Access Compliance Report

Public Rights-of-Way

(Curb Ramps)

Intersection ID: 10451	Main Street: CHARLES_AV	Cross Street: E_36TH_ST	Location: S
ADA ID: 579B3D91A671	Ramp Type: Perp	Initial Pass/Fail: Fail	Overall Compliance: No
Severity Score: 8.75			
Codes/Mitigation Info/Possible Solution		Field Measurements/Component Compliance

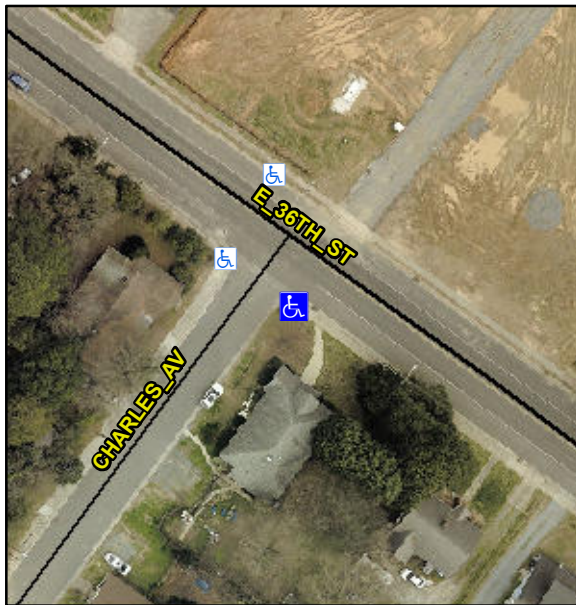
Not Found, R304.5.1

Compliance	Description	Data	Compliance	Description	Data
N/A	Ramp Length (in)	63.0	Yes	Ramp Slope (%)	5.8
No	Ramp Width (in)	47.5	Yes	Ramp XSlope (%)	1.6
N/A	Flare Type LT	N/A	N/A	Flare Type RT	N/A
N/A	Flare Slope LT (%)	N/A	N/A	Flare Slope RT (%)	N/A
N/A	Flare Traversable LT?	N/A	N/A	Flare Traversable RT?	N/A
N/A	Landing Length (in)	N/A	N/A	DWS Provided?	N/A
N/A	Landing Width (in)	N/A	N/A	DWS Contrast?	N/A
N/A	Landing Slope (%)	N/A	N/A	DWS Length (in)	N/A
N/A	Landing X Slope (%)	N/A	N/A	DWS Full Width?	N/A
N/A	Landing Curb? (Y/N)	N/A	N/A	DWS Offset (in)	N/A
N/A	Shared Landing?	N/A			
N/A	Gutter Ponding?	N/A	N/A	Gutter Slope (%)	N/A
N/A	Gutter Lip Ht (in)	N/A	N/A	Gutter X Slope (%)	N/A
N/A	Painted X Walk1?	No	N/A	Painted X Walk2?	N/A
	X Walk 1 Direction	To NW		X Walk 2 Direction	N/A
N/A	X Walk 1 Width (in)	N/A	N/A	X Walk 2 Width (in)	N/A
	X Walk 1 Slope (%)	0.8		X Walk 2 Slope (%)	N/A
	X Walk 1 X Slope (%)	0.2		X Walk 2 X Slope (%)	N/A

Remove & Replace Entire Ramp.
